**SERVICE PROGRAM BULLETIN**

**APPLICABILITY:** 2021 MY Ascent  
 2021 MY Legacy 2.4L turbo  
 2021 MY Outback 2.4L turbo

**NUMBER:** WRF-21  
**DATE:** 07/28/21

**SUBJECT:** EGI Harness and ECM Replacement Voluntary Emissions Recall

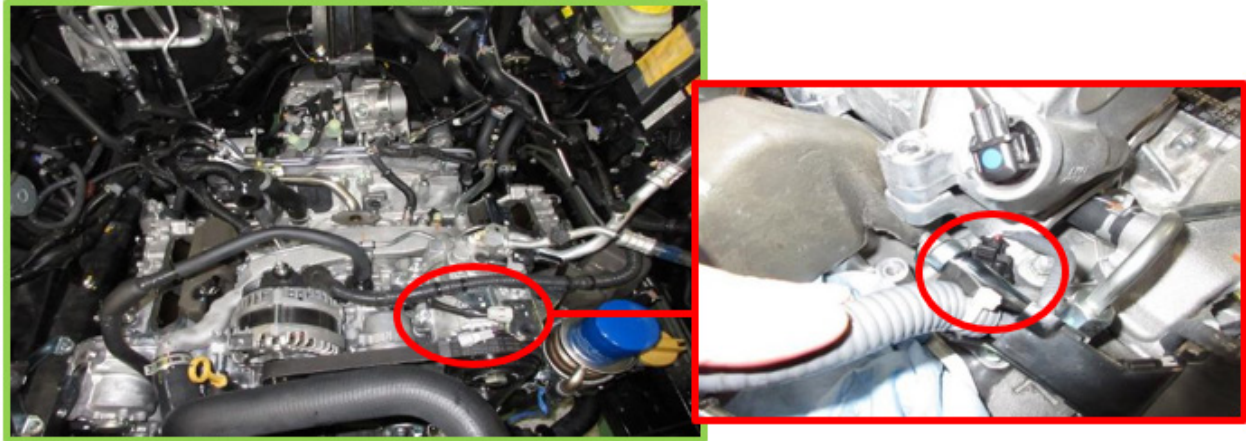
- REV. 1)** Remove the two bolts securing the engine oil cooler pipe. DO NOT remove the water hose. This will eliminate engine coolant loss.

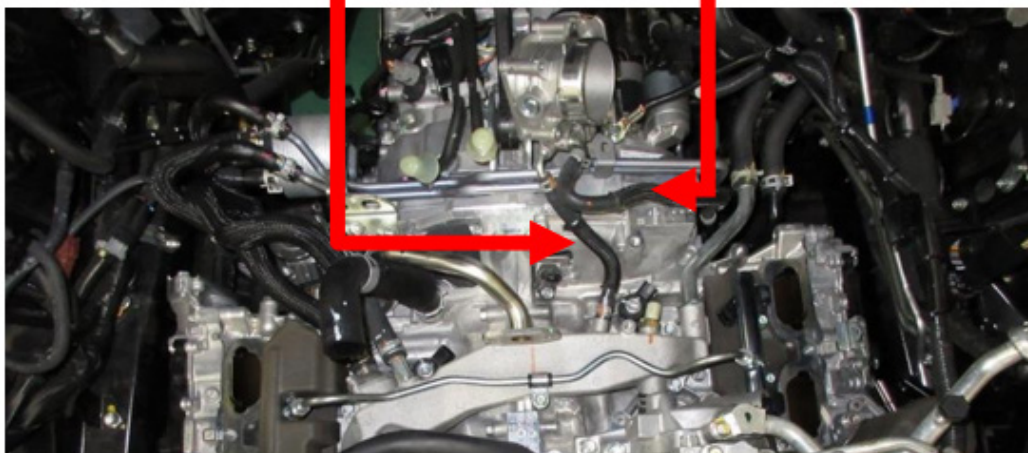
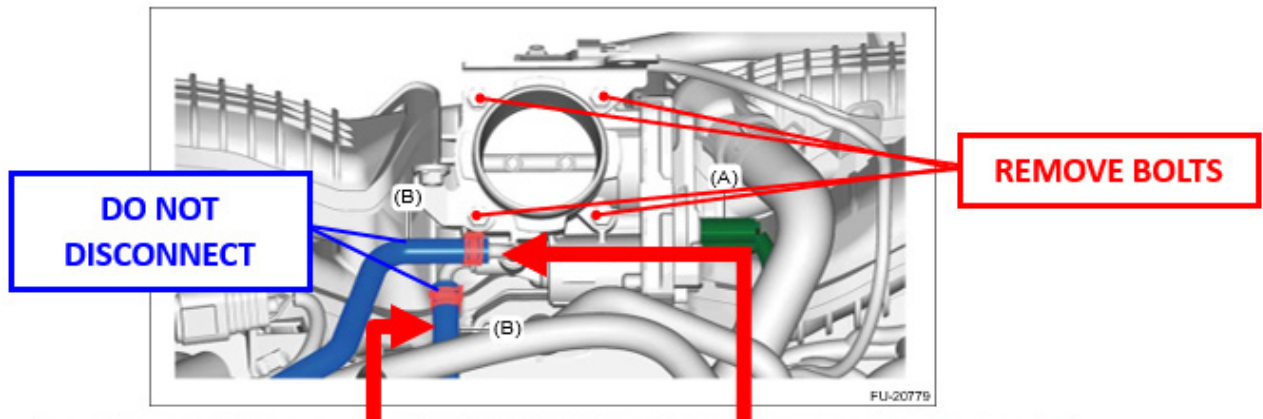
**REV. 3)** The throttle body assembly does not have to be fully removed. Remove the four mounting bolts and disconnect the wiring harness connection (A). The throttle body assembly can be repositioned with the pre-heater (coolant) hoses (B) attached to allow sufficient access. Use **CAUTION** to not damage the throttle plate during this procedure.

CO-10185

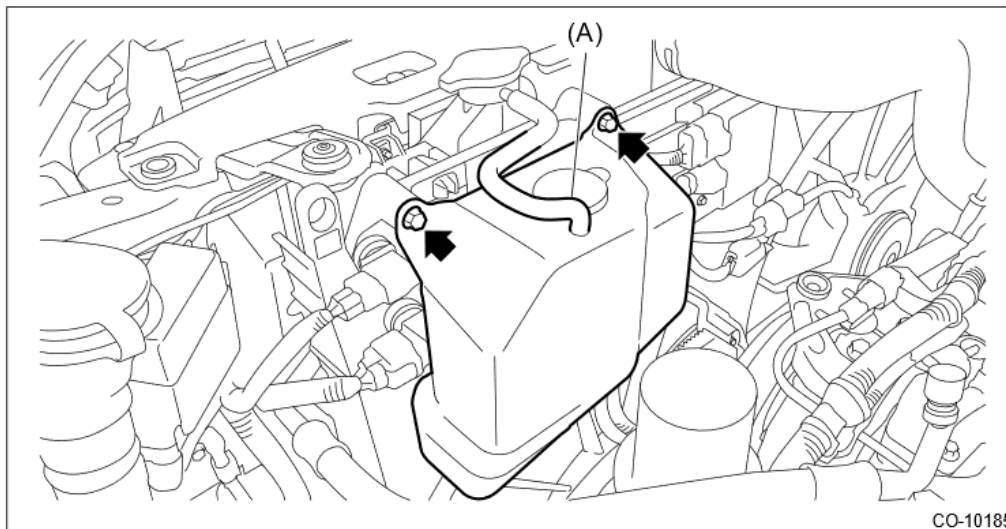
- REV. 4)** Remove the coolant reservoir tank to gain easy access to the connectors located in this area.
